Limerick Generating Station, Units 1 and 2
Renewed Facility Operating License Nos. NPF-39 and NPF-85
NRC Docket Nos. 50-352 and 50-353

Subject: License Amendment Request for Application to Adopt TSTF-477, Revision 3, "Add Action for Two Inoperable Control Room AC Subsystems" and Associated Technical Specification Changes

License Amendment Request

Figure 2

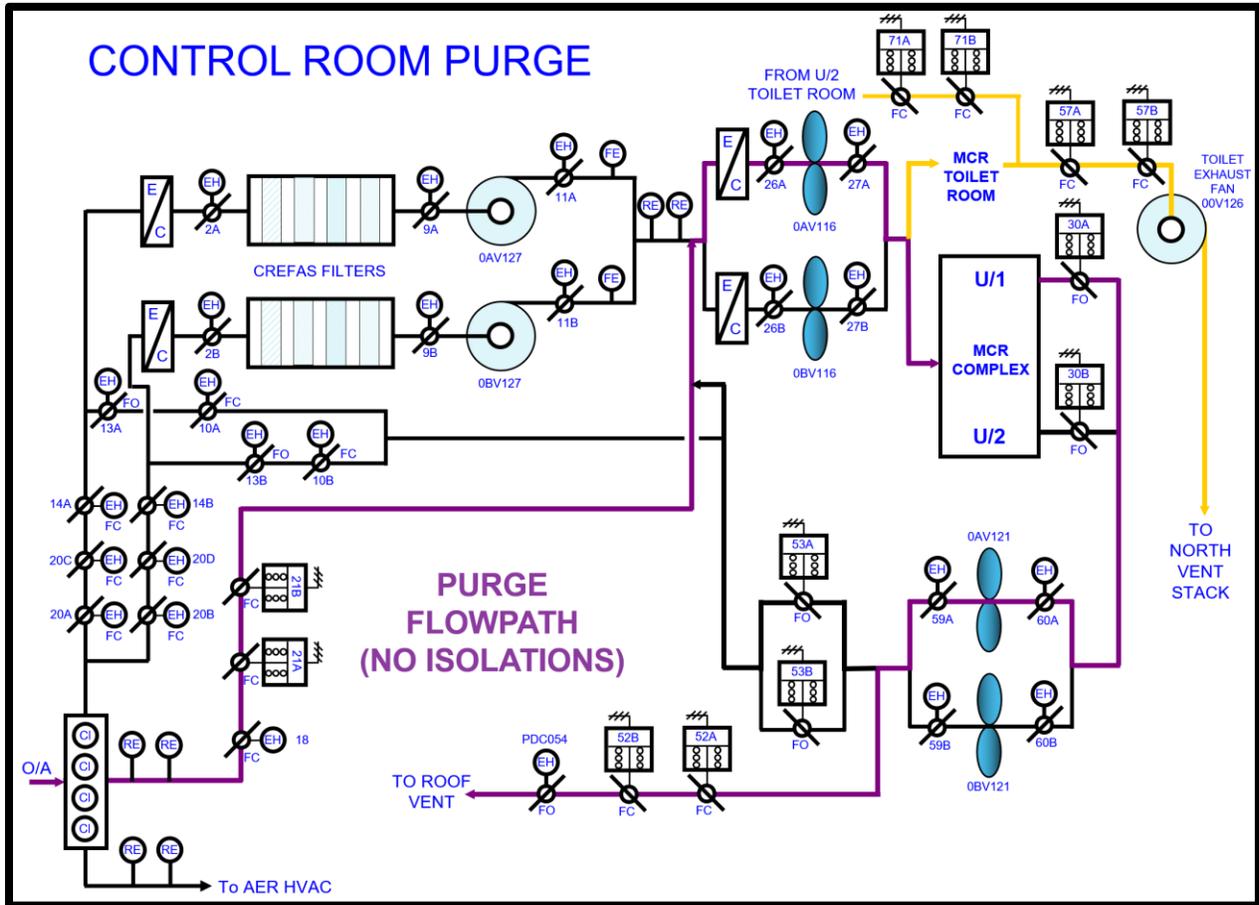
Additionally, as described in the UFSAR, the MCR HVAC system also has a purge mode of operation. Its function is to purge the areas served by the control room HVAC system of smoke from a fire by using a 100% fresh air supply and exhausting 100% of the air (See Figure 2 of this Attachment).

Figure 3

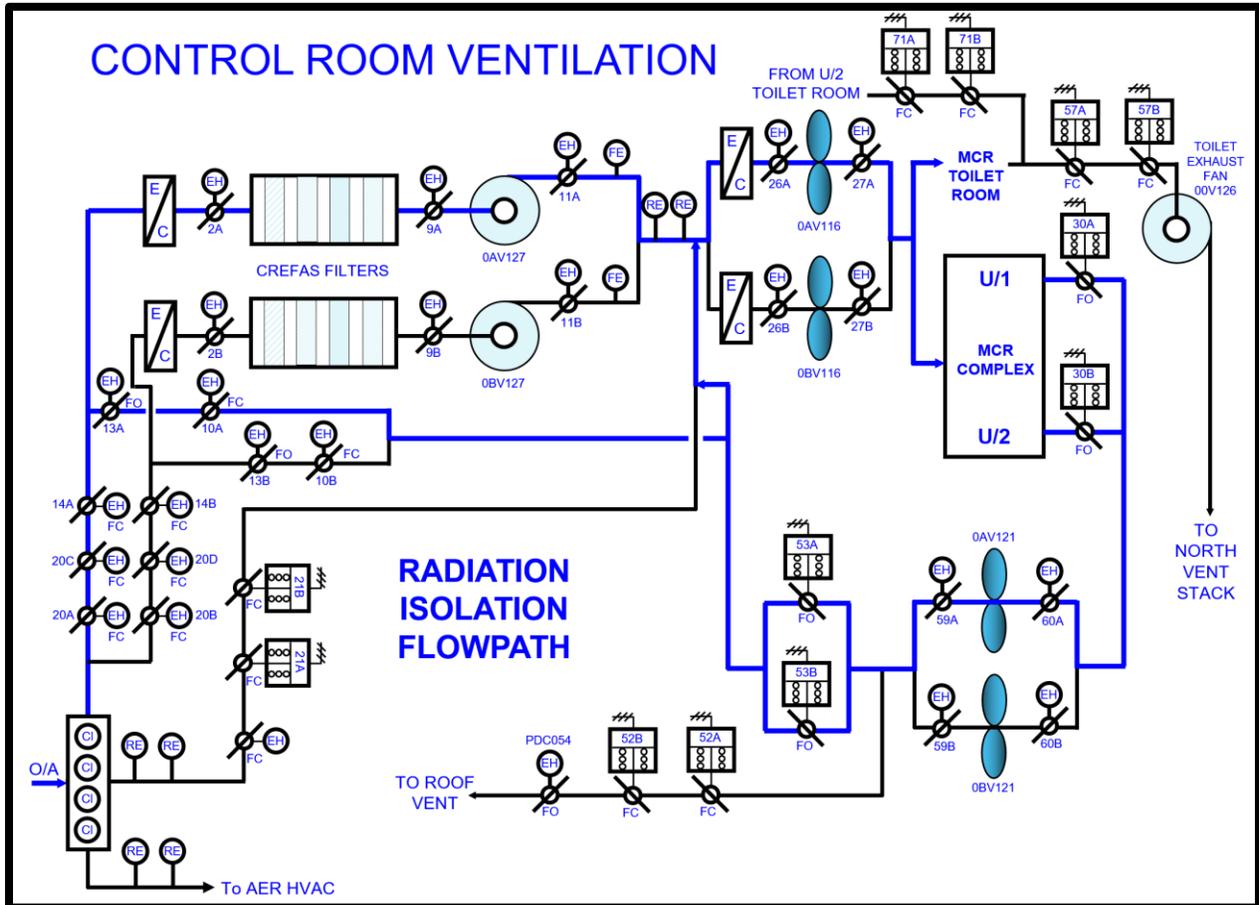
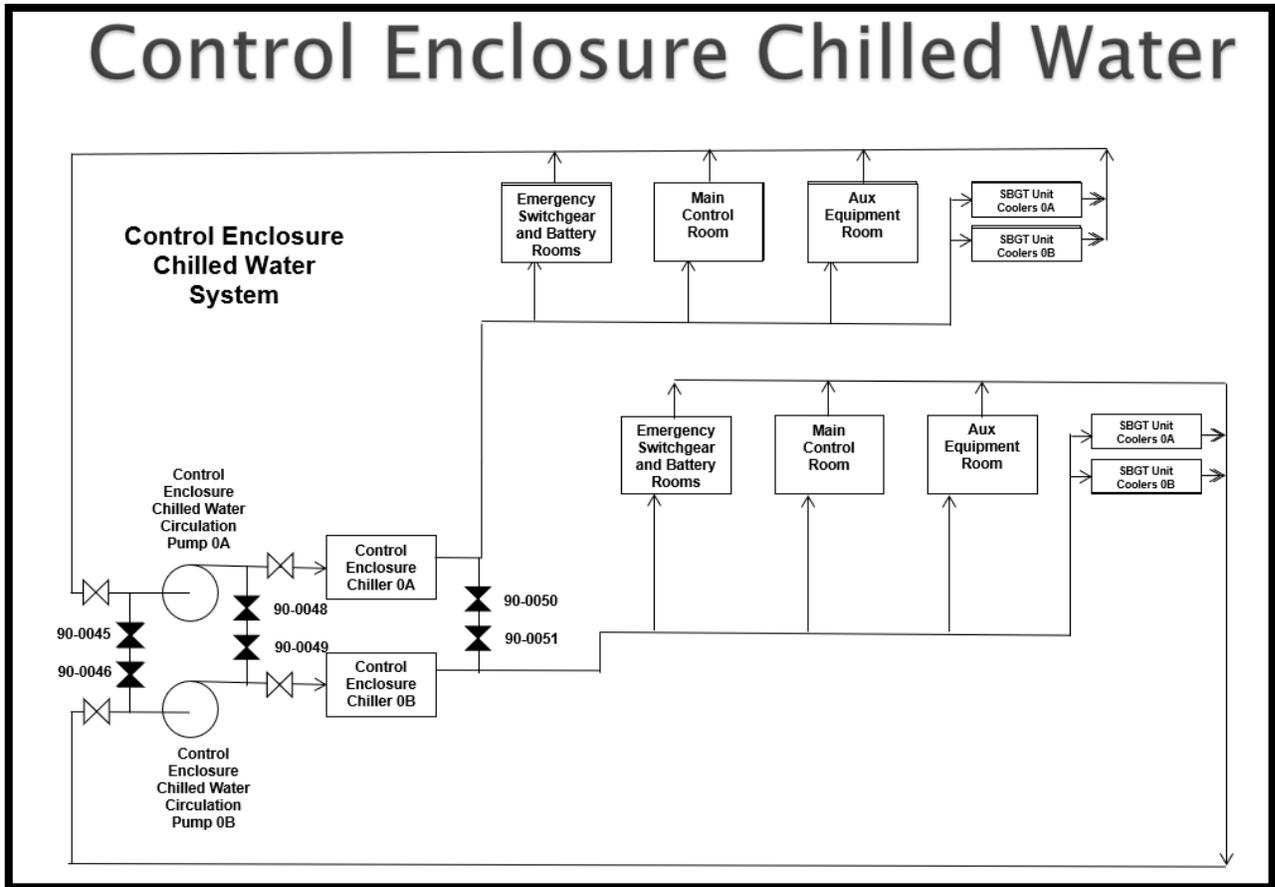
The purge mode of operation is overridden and cannot be used for cooling when the control room is automatically isolated on high radiation when the CREFAS is required in the event of a DBA (See Figure 3 of this Attachment).

If an automatic isolation condition were to occur in the event of a DBA concurrently while both control enclosure chillers or subsystems are out of service using the purge mode of operation for cooling, outside air cooling is reduced to a flow rate (525 cfm or less) only needed to maintain the MCR pressurized. The CREFAS pressurization mode of operation DBA safety function is to filter contaminated inlet air for pressurization and filter a portion of recirculated MCR air to limit occupant's radiological dose to less than or equal to 5 rem TEDE for the accident duration (See Figure 3 of this Attachment).
